711 HUNTER STREET, NEWCASTLE WEST - DA2022/01316 (PPSHCC-159) AND DA/2022/01317 (PPSHCC-160)

1. INTRODUCTION

Both applications were deferred on 8 August 2023 following a Hunter and Central Coast Regional Planning Panel (**the Panel**) briefing meeting on Thursday 27 July 2023. The reasons for deferral were common between the two applications and the Panel outlined the following reasons:

Figure 1 – Carparking headlight spill

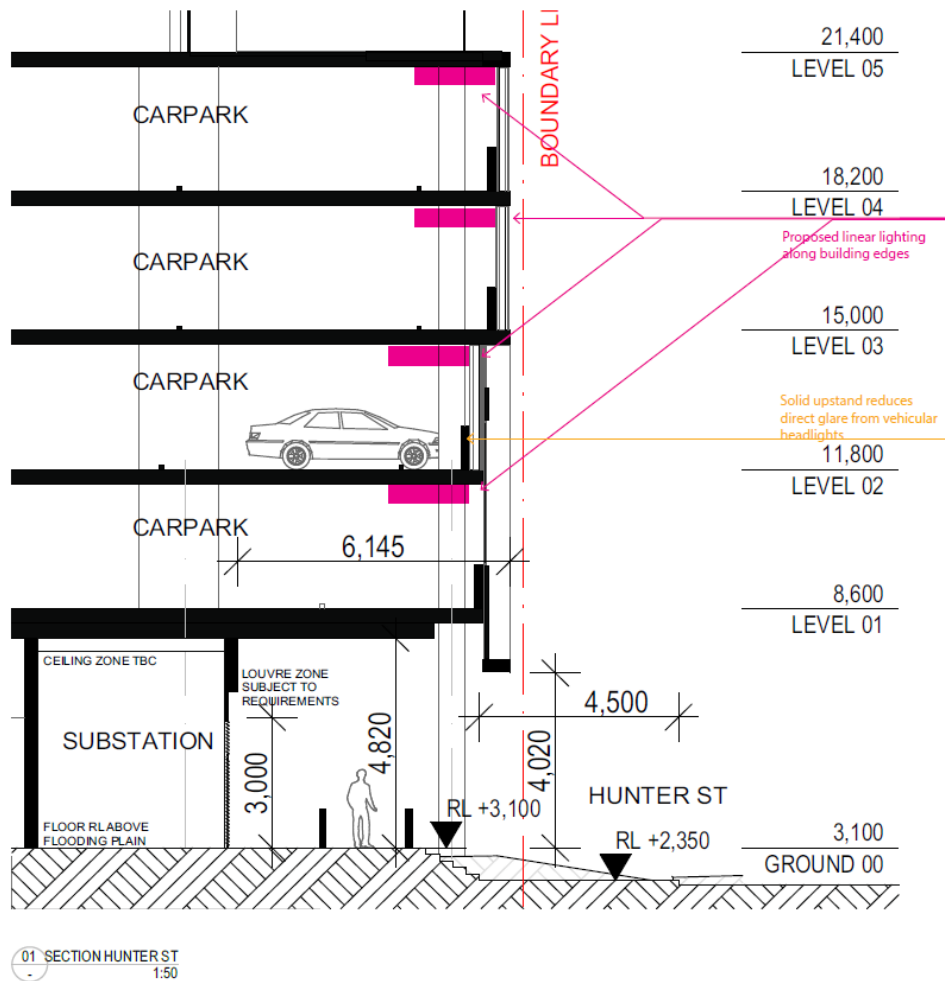
Panel Comment: *Amended plans and details relating to carpark façade and lighting including material finishes.*

Response: In response to the headlight, a spill solid upstand are the car park edges has been implemented to mitigate direct glare from vehicles as they manoeuvre through the car park, refer to Figure 1. This will provide filtering of artificial light that will appear in an interesting and less impactful way.

Lighting will also be provided in the car park that will be censored, to ensure the car park is still safe but reduce lighting and the amount of energy, light pollution, and impact on light spill. The lights will be motion sensed to reduce energy, light pollution and light spill when not required.

Further, the car park will be illuminated will allow for safer drivers and pedestrians that vehicles will visibly see including road markings, signs, paths of egress. Minimising the need for drivers to use their headlights. These resolutions were presented at DIP Session no. 2 and considered resolved by the DIP.
